Addendum

DS2.1, 2003-08-04

DELIC-LC/DELIC-PB

PEB 20570/PEB 20571/PEF 20570/PEF 20571 Version 3.1

Figure 1 Clocking the VIP by using DELIC Layer 1 Clock

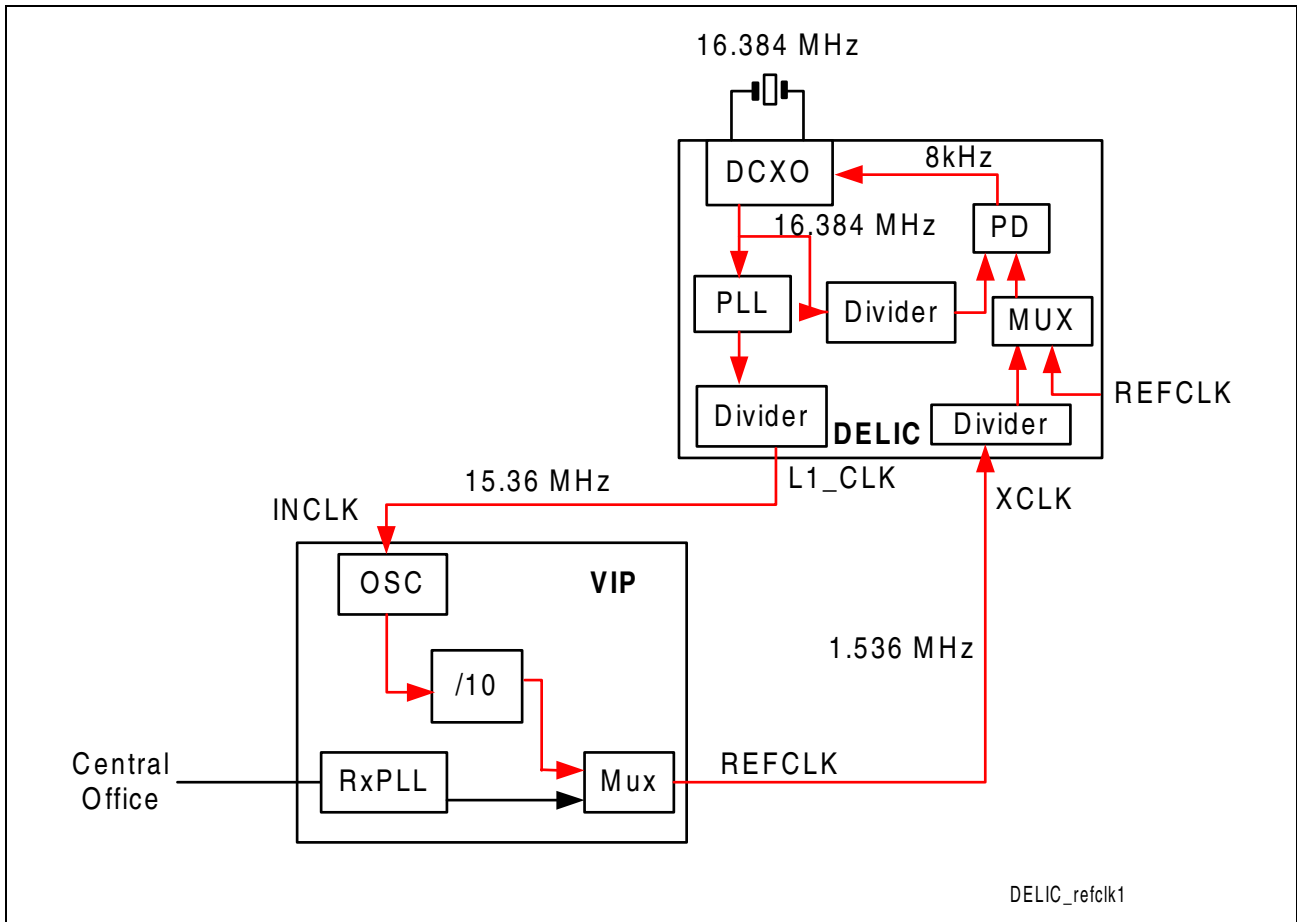
When the Central Office is deactivated, the VIP takes its oscillator signal of 15.36 MHz (the DELIC Layer 1 clock) divided by 10 and uses this signal as DELIC XCLK input as replacement of the Central Office clock.

As a consequence, the DELIC DCXO gets its own signal as input for the PD. Since the second PD input is also generated by the DCXO, the PLL system is unstable. This results in the DCXO and the PLL running to its respective corner frequency. Therefore, the 100 ppm clock accuracy, required by ITU-T I.430, cannot be guaranteed during this time. When switching to another clock source (REFCLK), the DELIC DCXO will work properly again.

Figure 3 Connecting the Crystal to the DELIC

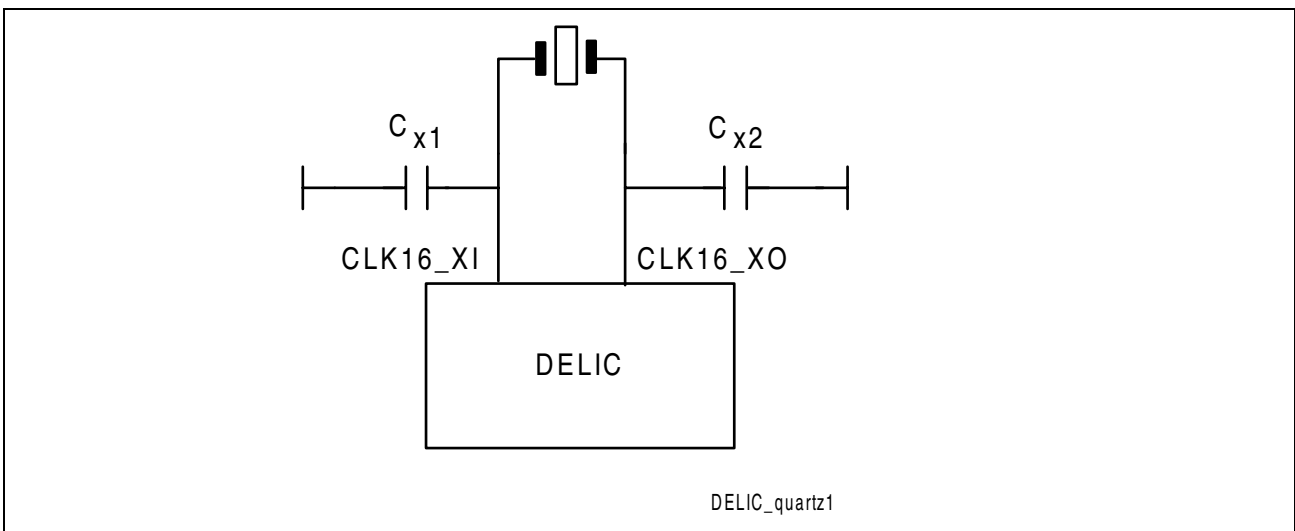
The following table and figures should be taken as a replacement of the “Recommended 16.384 MHz Crystal Parameters” of the DELIC-LC PEB 20570/PEF 20570 and DELIC-PB PEB 20571/PEF 20571.

The DELIC PLL pulls the external crystal by adding/subtracting capacitors (internal). By default, half of the internal capacitors are switched on at each pin (CLK16_XI and CLK_16XO).

Attention: On the DELIC Evaluation Board (SMART 2057, Infineon) C_{x1} and C_{x2} are 3.3 pF each. This value can be used as reference, but depends on the respective board design (for example layout).

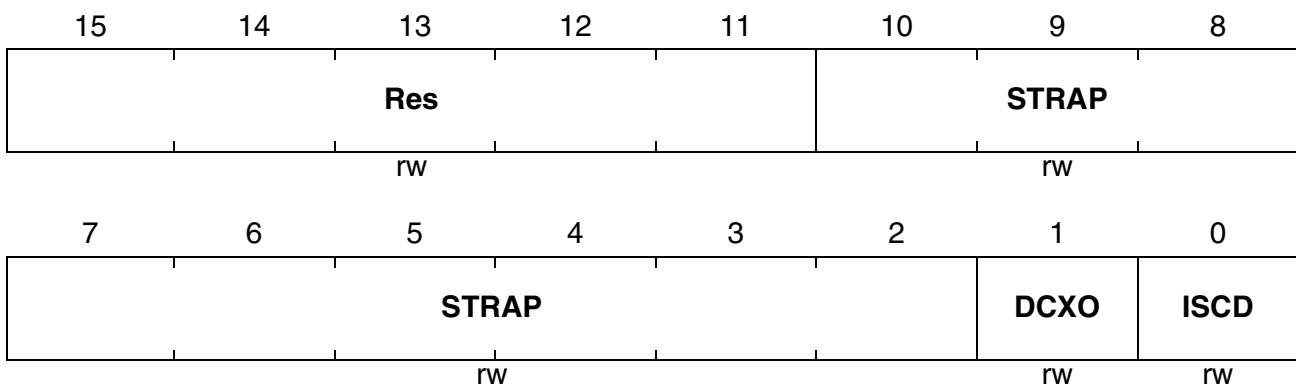
The DELIC “**Strap Status Register (CSTRAP)**” is described in the DELIC-LC PEB 20570/DELIC-PB PEB 20571 Data Sheet, independent of the version (2.1 .. 3.1). The register description (see updated register **CSTRAP**) of the Data Sheet is misleading concerning bit 0 and 1. They are **not** configured by strap option. For a stable DCXO synchronization it is recommended to proceed as follows:

1. After Boot read register CSTRAP to detect the value
2. Set only bit CSTRAP:**DCXO** to '0' and set the others as detected before
